Access Compliance Report

Public Rights-of-Way

Intersection ID: 53162	Main Street: OBAN_CT	Cross Street: HAMILTON_BRIDGE_RD	Location: SW
ADA ID: F3442A599C71	Ramp Type: BlendTrans1	Initial Pass/Fail: Fail	Overall Compliance: No
		Severity Score: 8.75

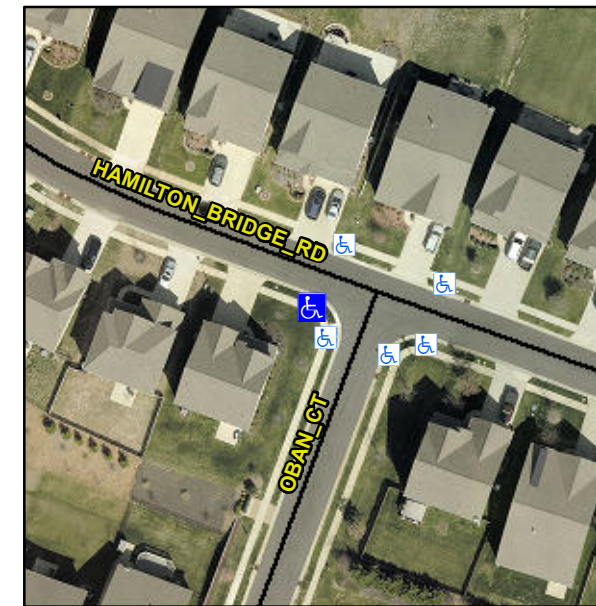
R304.5.1

Compliance	Description	Data	Compliance	Description	Data
N/A	Ramp Length (in)	49.5	Yes	BlendTrans Slope (%)	3.0
No	Ramp Width (in)	45.0	Yes	BlendTrans XSlope (%)	1.2
N/A	Flare Type LT	N/A	N/A	Flare Type RT	N/A
N/A	Flare Slope LT (%)	N/A	N/A	Flare Slope RT (%)	N/A
N/A	Flare Traversable LT?	N/A	N/A	Flare Traversable RT?	N/A
N/A	Landing Length (in)	N/A	N/A	DWS Provided?	N/A
N/A	Landing Width (in)	N/A	N/A	DWS Contrast?	N/A
N/A	Landing Slope (%)	N/A	N/A	DWS Length (in)	N/A
N/A	Landing X Slope (%)	N/A	N/A	DWS Full Width?	N/A
N/A	Landing Curb? (Y/N)	N/A	N/A	DWS Offset (in)	N/A
N/A	Shared Landing?	N/A			
N/A	Gutter Ponding?	N/A	N/A	Gutter Slope (%)	N/A
N/A	Gutter Lip Ht (in)	1.0	N/A	Gutter X Slope (%)	N/A
N/A	Painted X Walk1?	No	N/A	Painted X Walk2?	N/A
	X Walk 1 Direction	To NE		X Walk 2 Direction	N/A
	X Walk 1 Width (in)	N/A		X Walk 2 Width (in)	N/A
	X Walk 1 Slope (%)	4.7		X Walk 2 Slope (%)	N/A
	X Walk 1 X Slope (%)	3.4		X Walk 2 X Slope (%)	N/A

Remove & Replace Curb Ramp With Two New Directional Ramps or Equivalent.
